SUBJECT: Drag Brace Weld Clearance Inspection

APPLICATION: All Glasair III aircraft prior to kit number 3295.

MODEL	ASSEMBLY NAME	REVISION	DATE	VOLUME	PAGE
GLASAIR III	SERVICE BULLETIN 129		1/10/95		1 of 2

FIGURE (1)

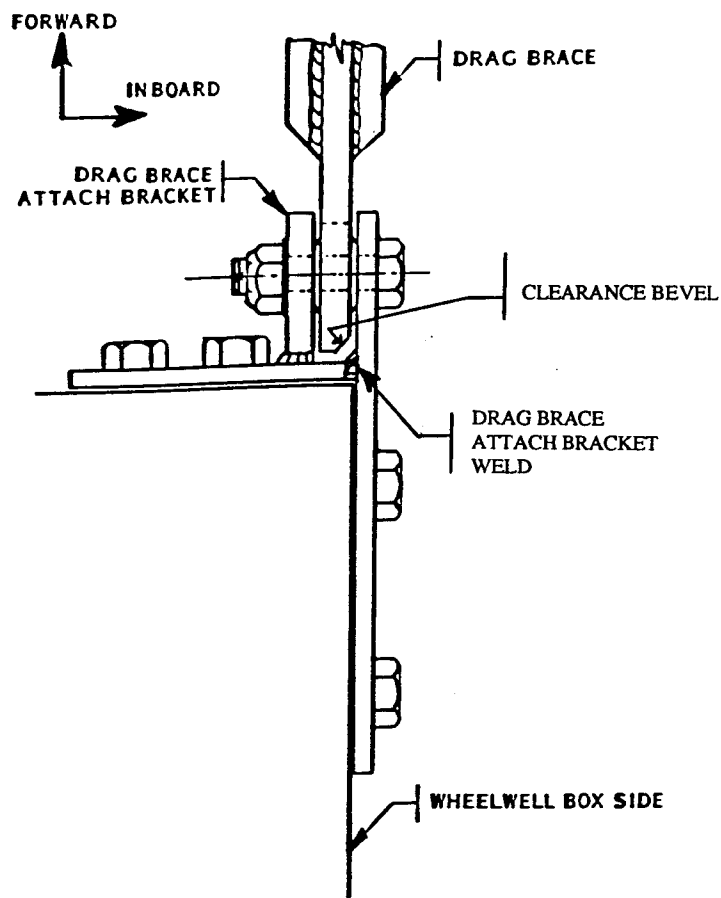
DESCRIPTION: Some Glasair III nose gear drag braces (363-5410-101) may have been fabricated without proper clearance bevels. The bevels provide clearance between the aft edges of the drag brace arms and the welds on the drag brace attach brackets, as shown in FIGURE (1). Improper clearance can cause additional friction during gear operation and may effect proper retraction or extension of the nose gear.

REQUIRED ACTION: A one-time inspection is required to verify that the drag brace incorporates the bevels. The inspection is easily done even if the drag brace has been installed on the airplane. Visually confirm that the aft edge of the drag brace has a minimum of 1/16" clearance from the weld, as shown in FIGURE (1), throughout the entire range of travel of the drag brace.

FIGURE (2)

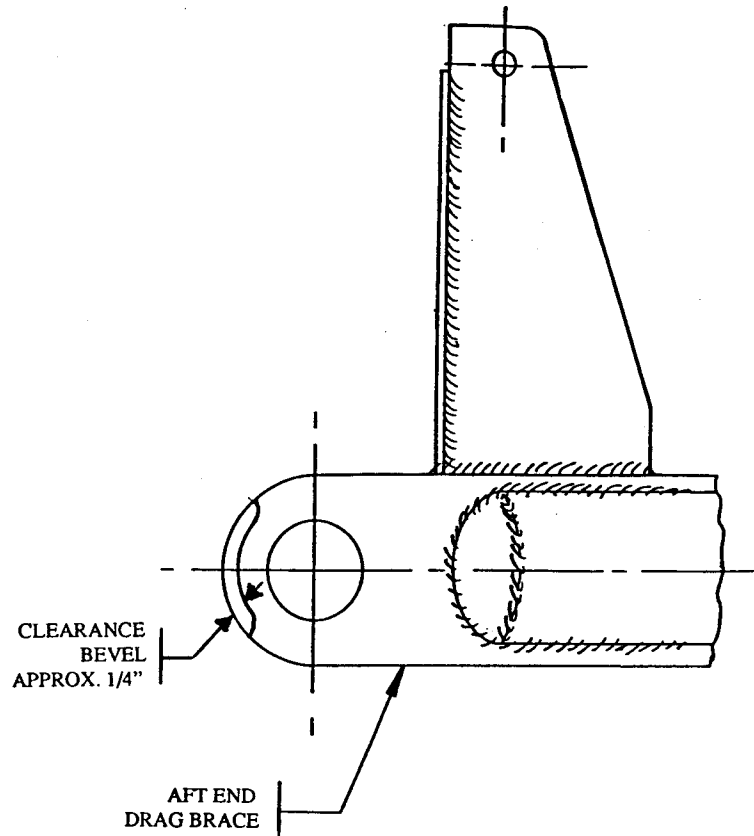
The drag brace must be removed from the aircraft and bevels trimmed onto its aft ends, as shown in FIGURE (2). This will require jacking the aircraft. The bevel can be cut using a file or a disc sander. Use a fine tooth file to smooth out the bevel after proper clearance has been achieved. Prime the exposed bare metal with an epoxy primer and touch it up with a white paint if desired.

Reinstall the drag brace and verify that the bevel provides adequate clearance from the weld.
